NAME OF PROPOSED DEVELOPMENT Lake Ray Hubbard Hotel + Conference Resort

Case No. 84-86-D/PP

SUBJECT LRHH & CR Comments

PROJECT: LAKE RAY HUBBARD HOTEL AND CONFERENCE RESORT
SITE PLAN/DEVELOPMENT PLAN APPROVAL

Diagram Section SL-SL
 Site-lines Diagram From Existing Residences
 Scale: 1"=20'

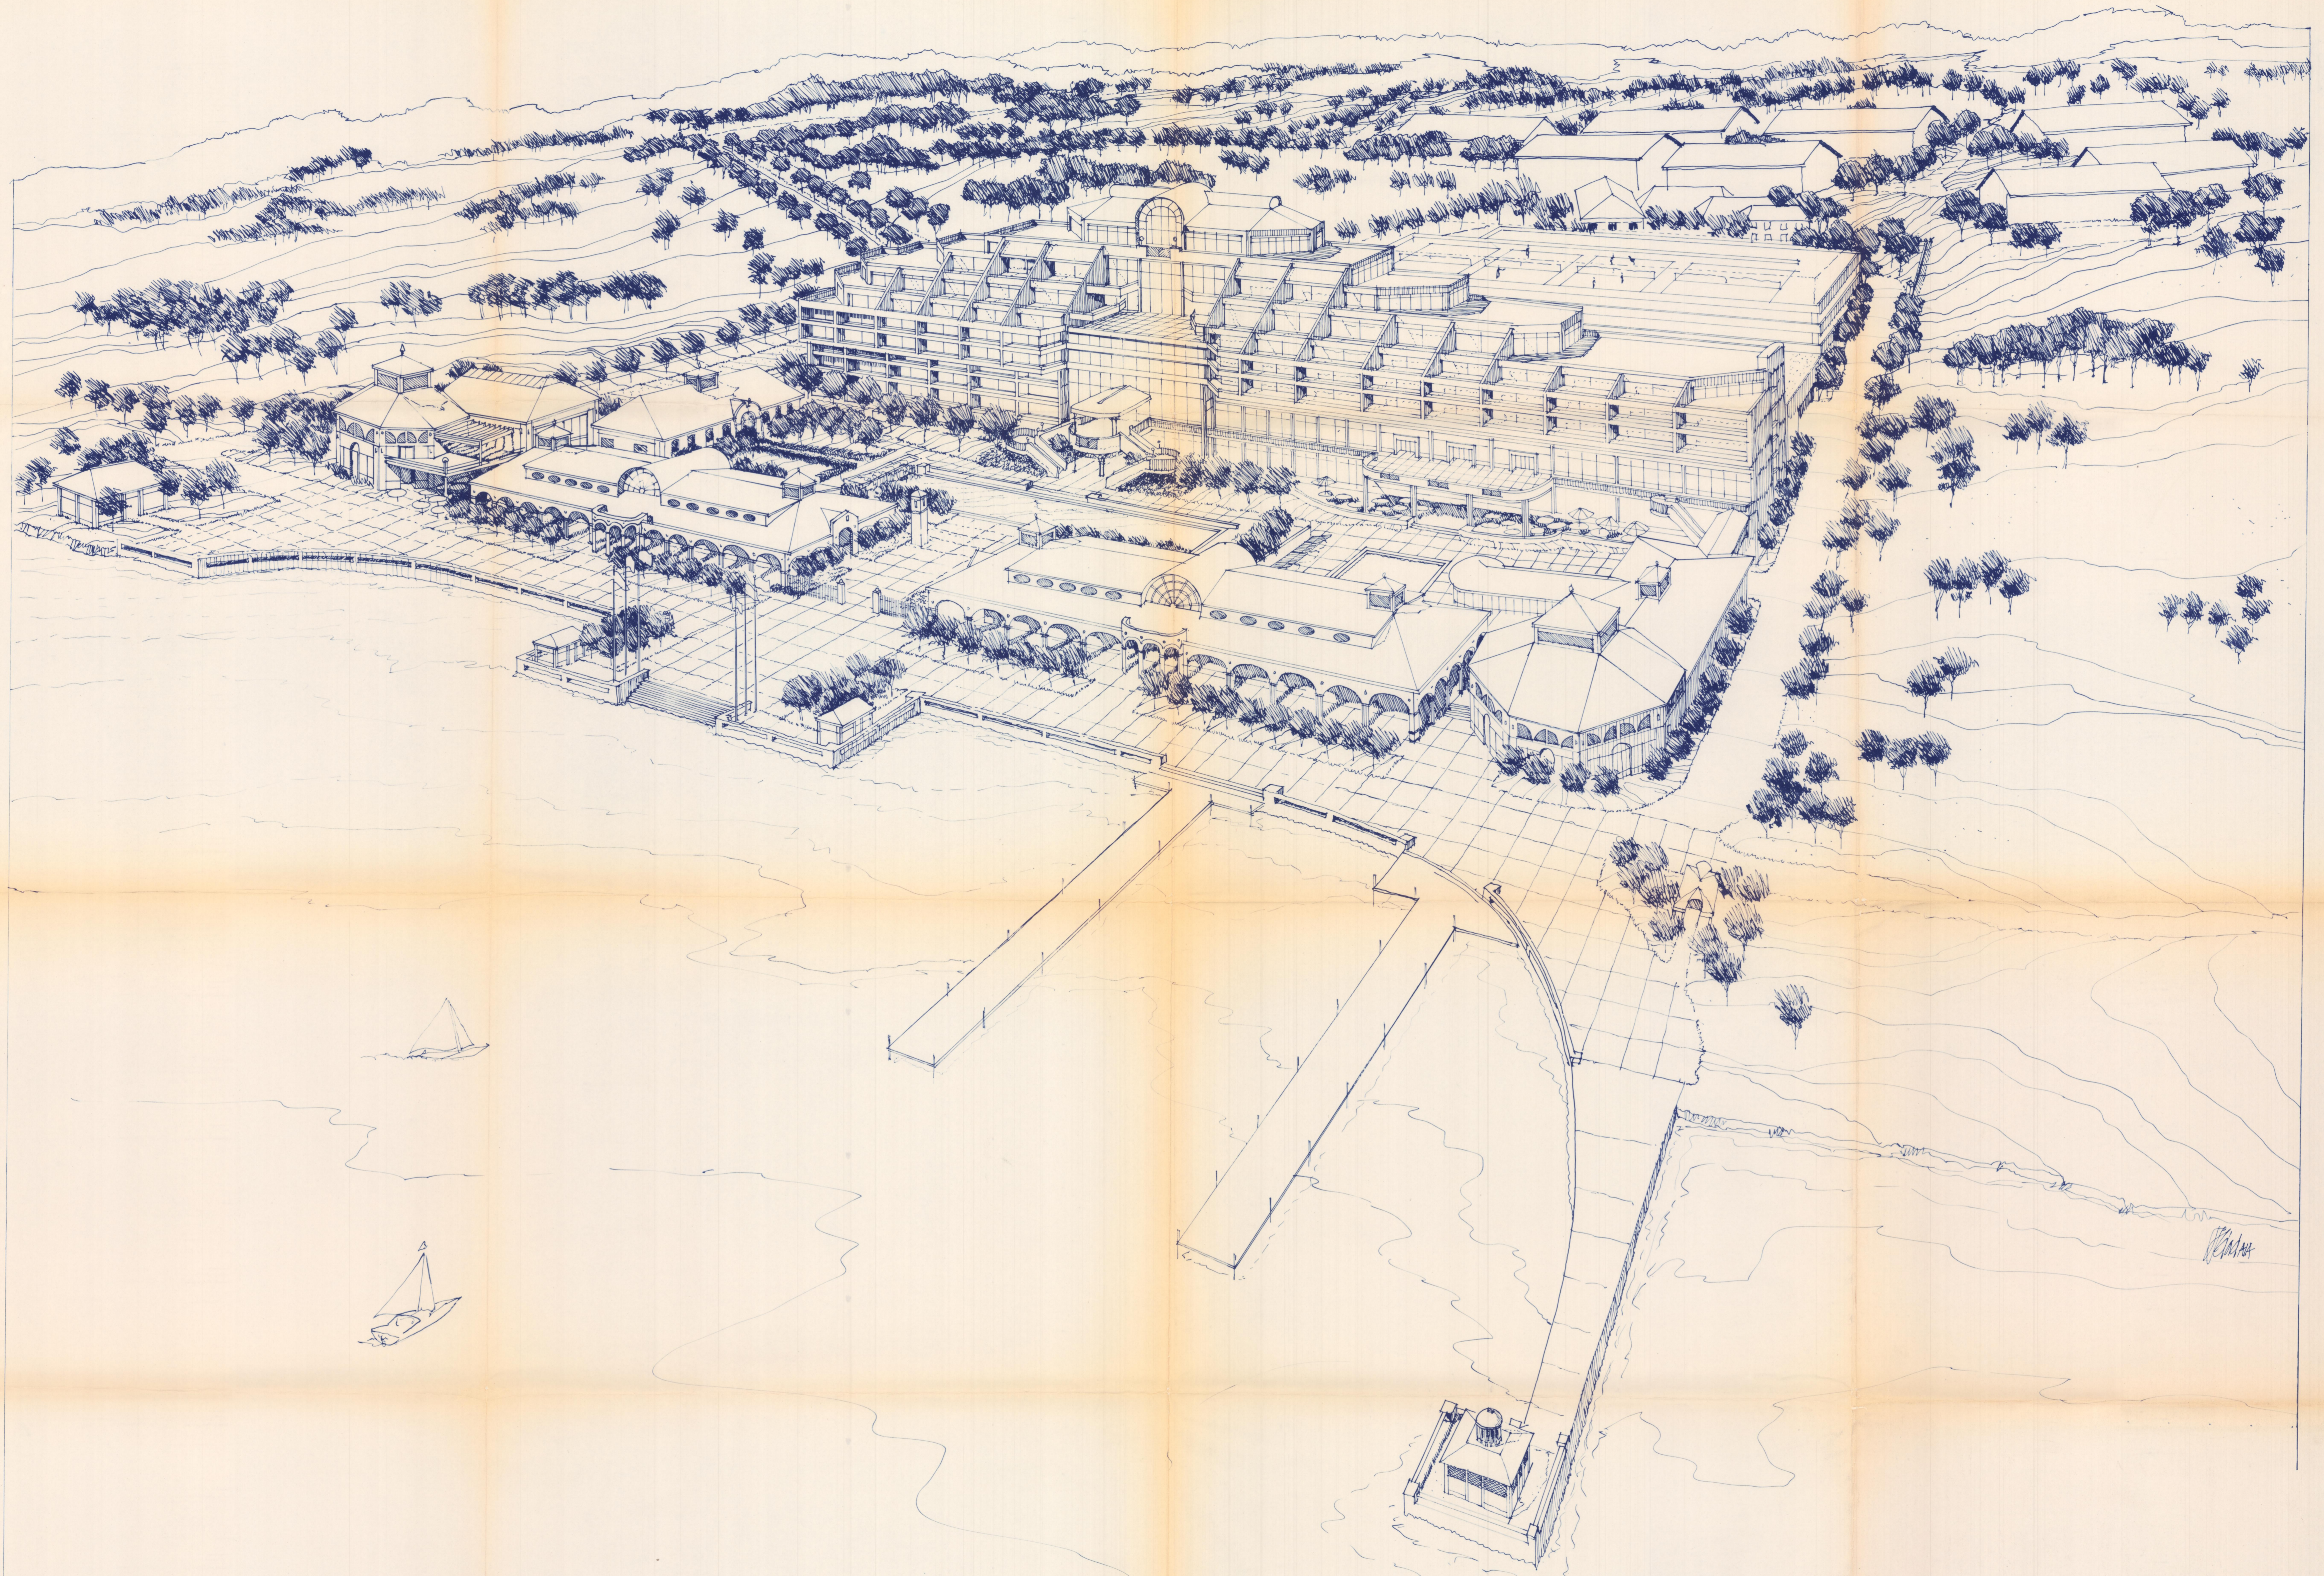
- 1. Our ordinance would require 755 parking spaces; can discuss overlap of guests/conference attendees, but not 297.
- 2. Guest buildings must be 20 ft. from property line abutting residential use.
- 3. Mark City of Dallas take line.
- 4. Fire lane must run between hotel and retail buildings.
- 5. Show dumpster locations.
- 6. How will delivery and garbage vehicles service retail buildings?
- 7. Show elevation relationship of existing Signal Ridge building to structures on site.

1. A rendering illustrating the entire project.
2. Diagram SL illustrating the probable site-lines from the residences in the structure immediately east and adjacent to the site, (Item 7, 7/27/84).
3. Schedule P defining the methodology used in determining the number of stalls required to meet Rockwall zoning requirements, and reasonably plan for variations in the schedules of the mixed uses on site. Note that we have revised our initial parking criteria, and that we have increased the parking count by 40 cars to 498. We believe, given this forecast, that this number adequately meets the needs of the project. (Item 1, 7/27/84)
